CITY OF ALEXANDRIA
HISTORIC PRESERVATION OFFICE
APPLICATION FOR BAR ADMINISTRATIVE
APPROVAL
APRIL 24, 2018

REPAIRS TO THE HISTORIC MAIN HOUSE
619 S LEE ST.
ALEXANDRIA, VA

BAR2018-00198

City of Alexandria
Board of Architectural Review
Staff Review
Address: 619 S LEE
 Not visible from public right-of-way.
 Interior work only. No exterior work authorized.
 Historically appropriate replacement or repair.
Staff: JIR Date: 4/25/18
for Director of Planning & Zoning

DETAILS & PHOTOGRAPHS - CHIMNEYS
619 S LEE STREET | ALEXANDRIA, VA

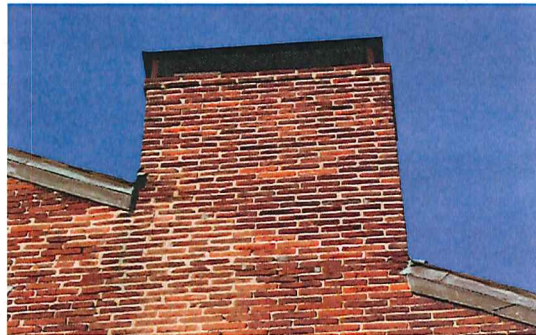
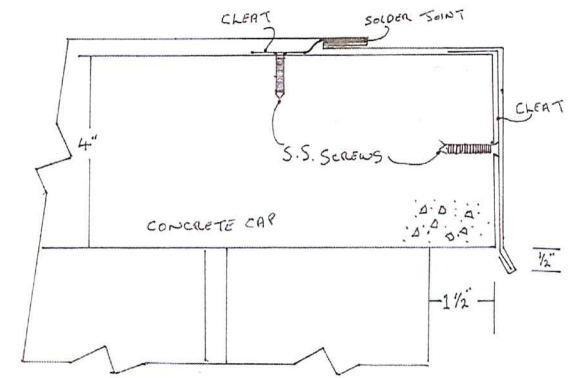
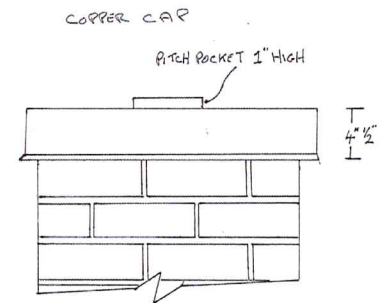
SEALER FOR CHIMNEY NOT
APPROVED.
